Anglia have been advised by the supplier TAICOM that a change has been made to the lead length from 5.8mm to 5.5mm for the below listed part numbers.

Date: 12/06/2020

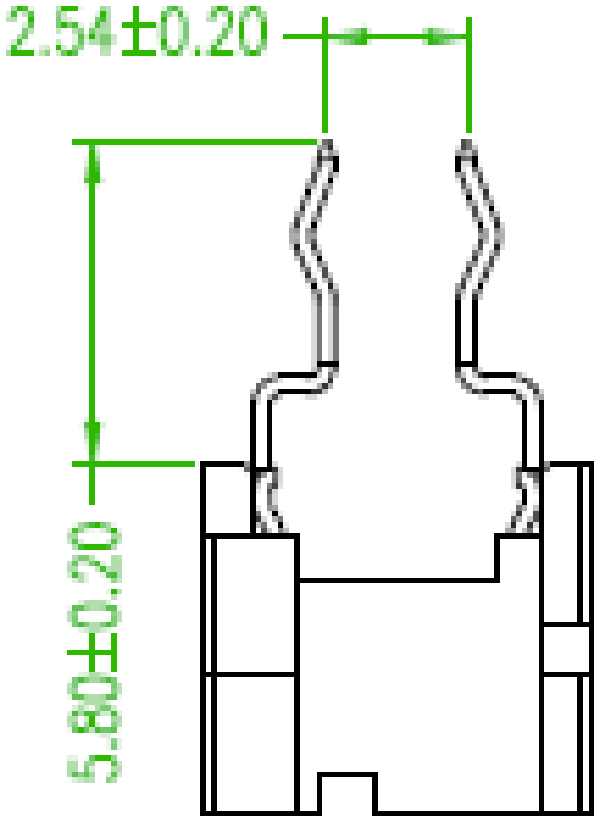
Attached below are the old and the new dimension for your evaluation

Old version 5.8mm

New version 5.5mm
